FOUNDATION INVESTIGATION REPORT

By: W.A. Trow & Associates, Inc.

Re: W.A. Trow & Associates, Inc. W.P. 116-99,  
Hwy. 100, W. 62, District 62.

Re: Stage Construction of Embankment  
Proposed Highway 2 over Sutherland Creek  
WP 116-59 & WP 177-60

SKETCH SHOWING SUGGESTED PIEZOMETER LOCATIONS

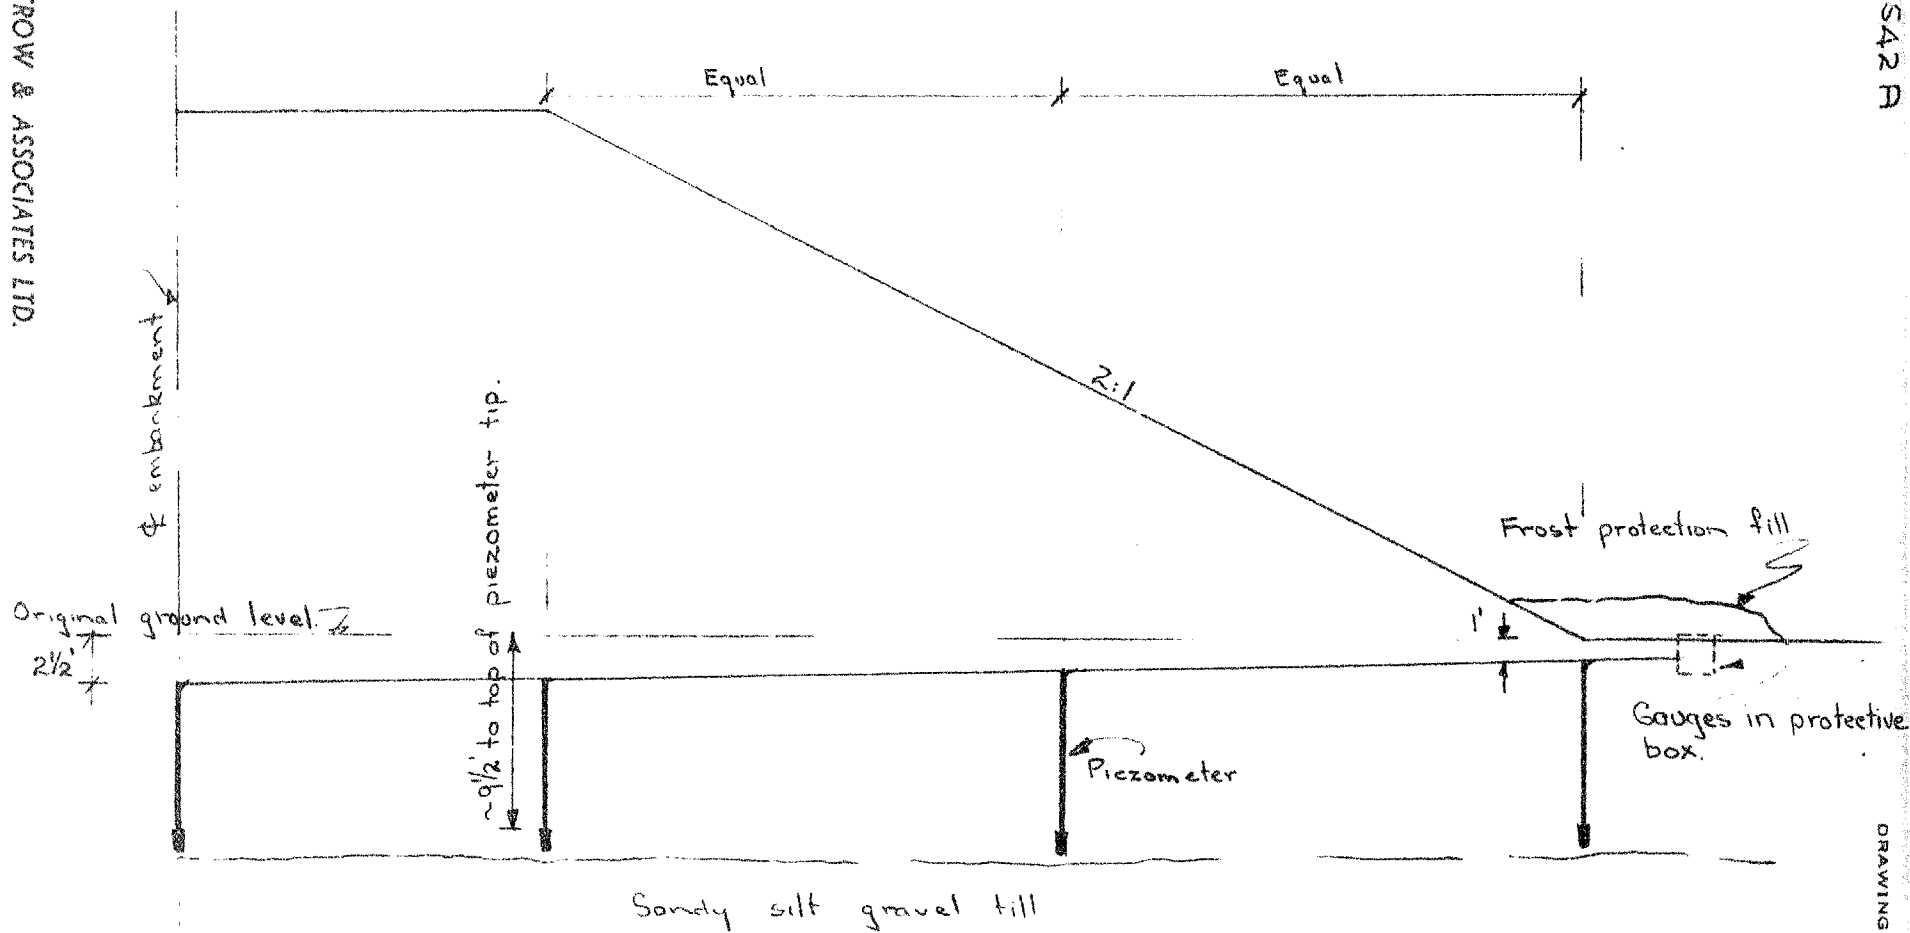
As indicated earlier in this letter, a direct estimate of the stability of the approach fill will be available from the measured pore pressures values. It is recommended that at least 4 piezometers be installed under each side of the embankment at two or three locations as indicated on the accompanying sketch.

It is understood that Geonor piezometer tips will be used. They should, of course, be installed before placement of the fill commences, so that a complete pattern of readings during and subsequent to load application may be obtained.

**ESTIMATED SUBSOIL STRATIGRAPHICAL PROFILE**  
 Scales: VERT. 1" = 10'  
 HORIZ. 1" = 20'

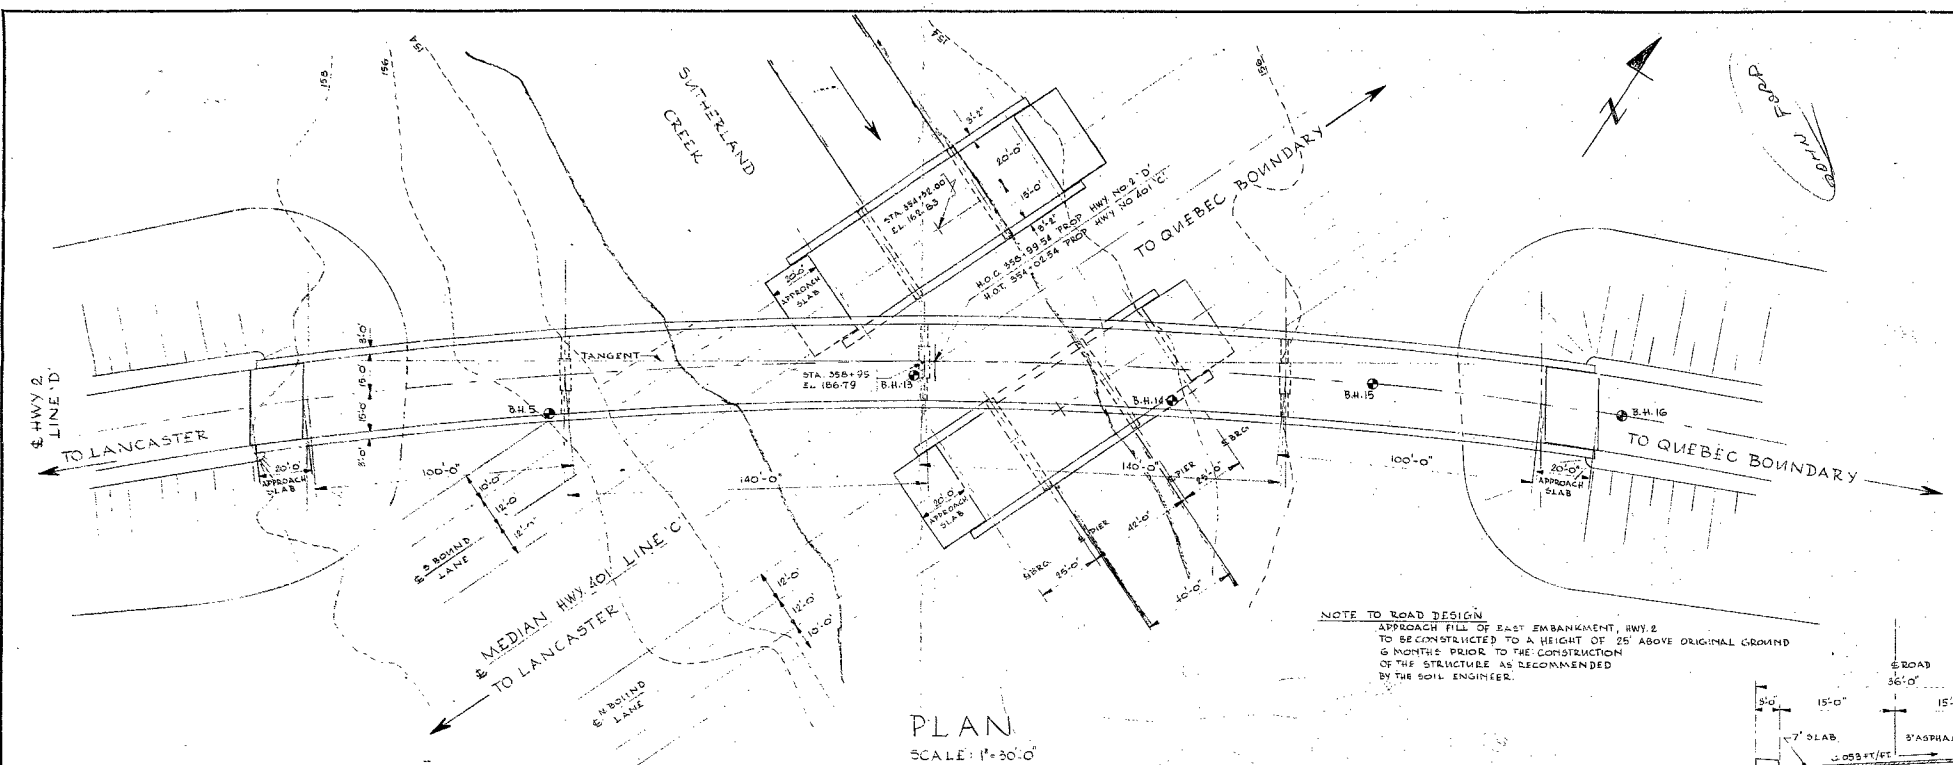
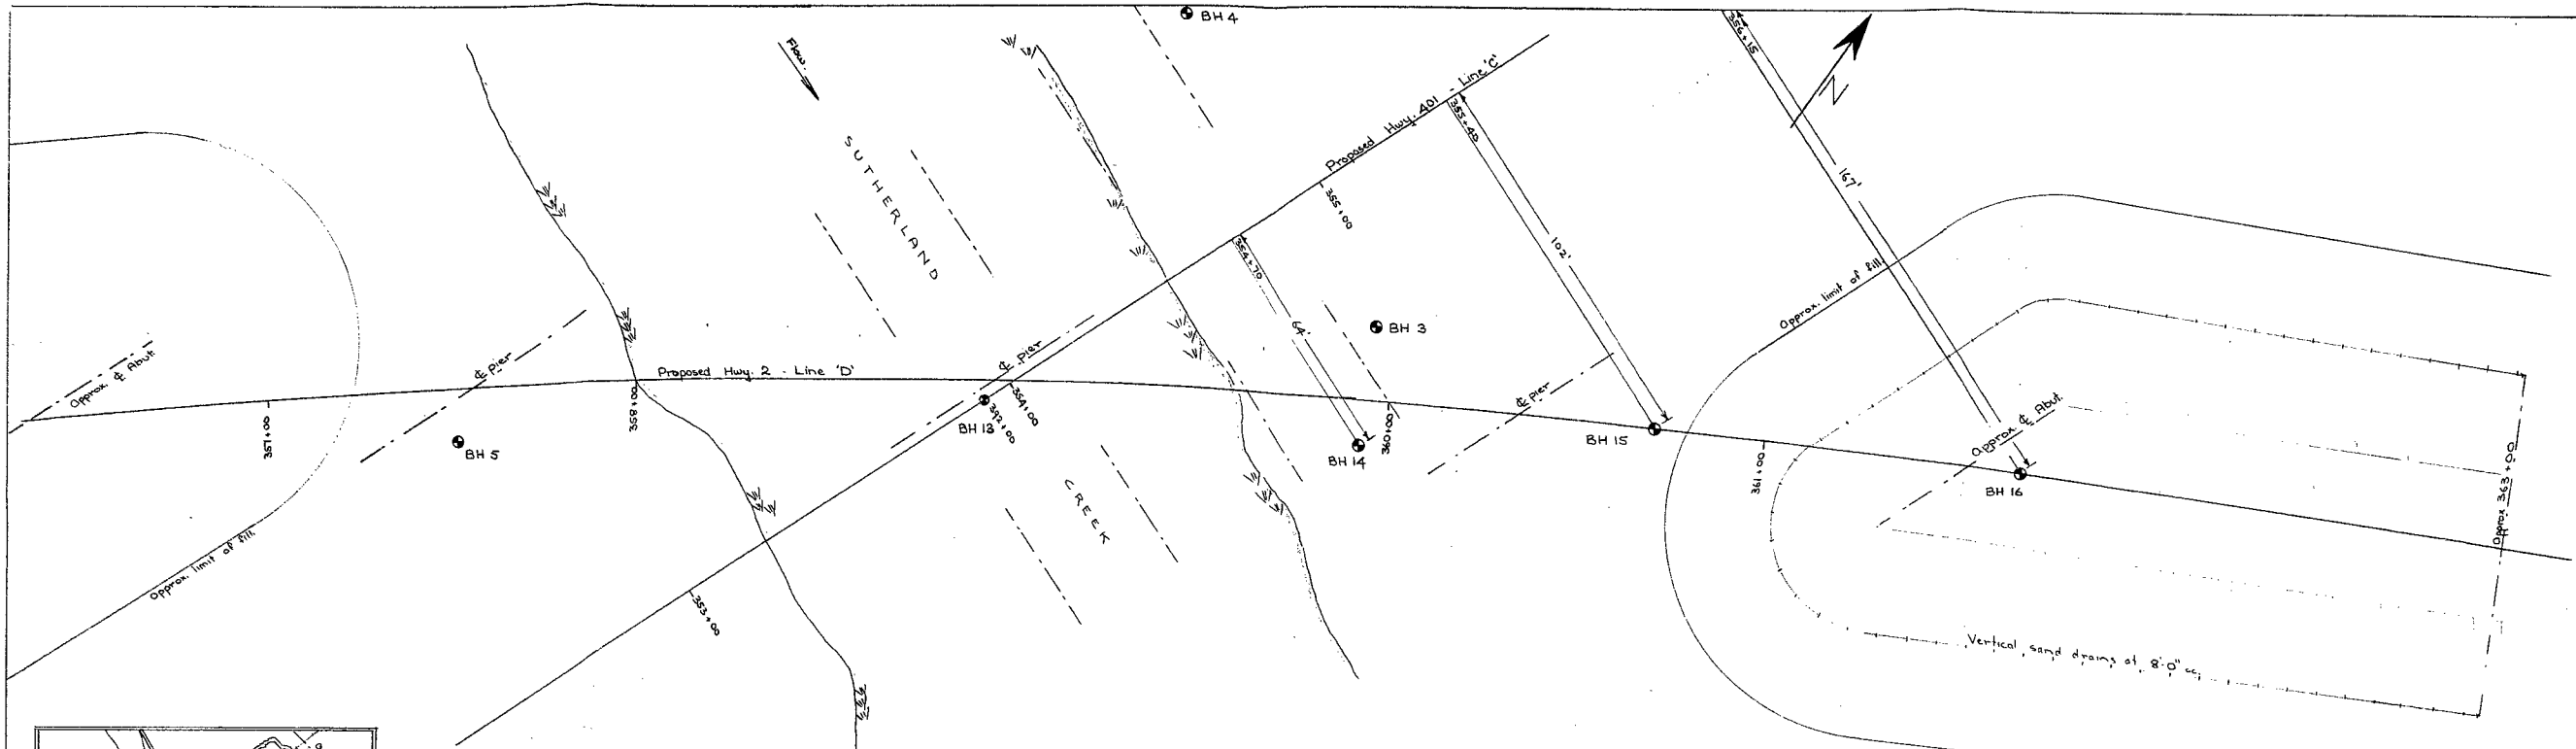
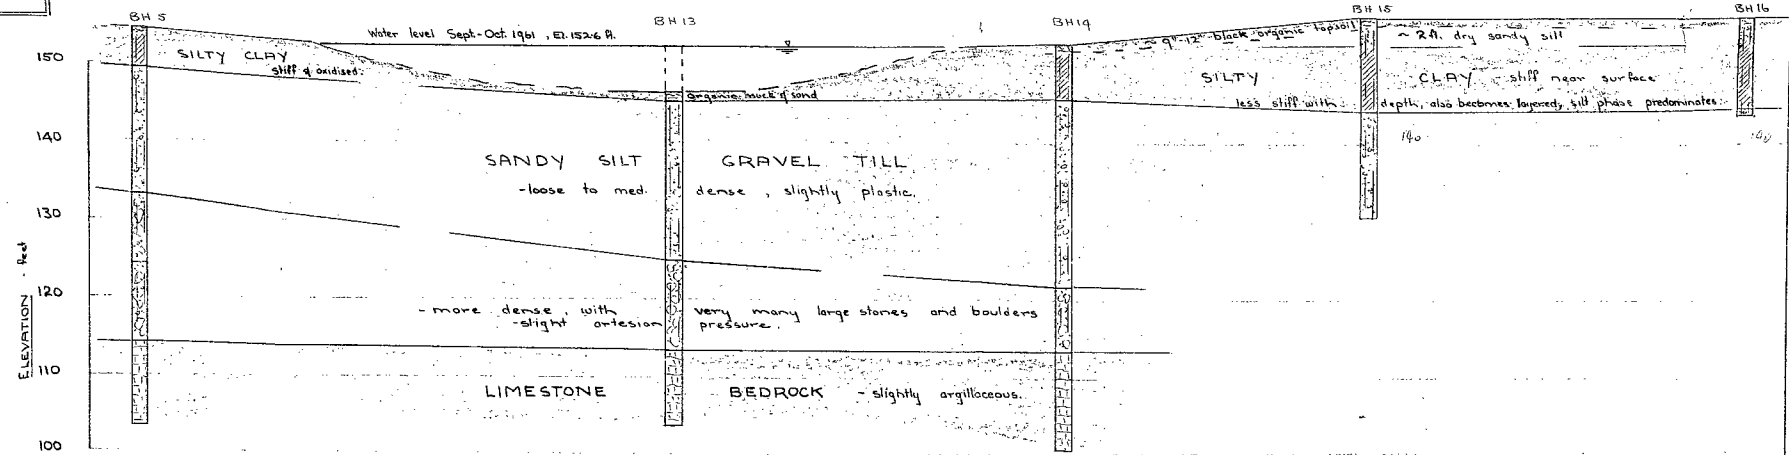
The Consultant has recommended the installation of sand drains for fills greater than 25' on the Hwy. #2 bridge approaches. The maximum height here, is 28'. This involves a section about 150' long on the East approach. We have discussed this matter with the Consultant and he is in agreement with our

suggestion that the installation of these drains will not be necessary provided that the section in question, is constructed to a height of 25', then left in place for a period of about 6 months prior to adding the additional material to complete the section to profile grade. We have also discussed this matter with the Road Design Section who are of the opinion that this procedure will cause only minor inconvenience and expense.

If a critical condition is anticipated from these pore pressure readings, the stability of the approach fill can be ensured by installing vertical sand drains at the toe of the embankment. No drilling through the embankment fill is therefore necessary.

It is understood that initial construction of the embankment to a height of 25 feet, with the addition of the remaining 3 feet of fill after a period of 6 months, can be incorporated in the construction programme. In addition, the site is to be fully instrumented with piezometers to determine the magnitude and extent of this lateral pore pressure migration. The question arises, therefore, of the necessity for the sand drains.

As indicated in the report, conservative assumptions of the nature of the pore pressure migration have had to be made. The piezometers, however, will provide direct measurements of pore pressure under the embankment. As this information becomes available, the possibility that the factor of safety will reduce to the low values quoted in the report, can be examined more exactly.

The installation of sand drains is therefore recommended to control these pore pressures, and thereby ensure a steady increase in safety after construction. The engineering computations which form the basis for these opinions are outlined in the report.
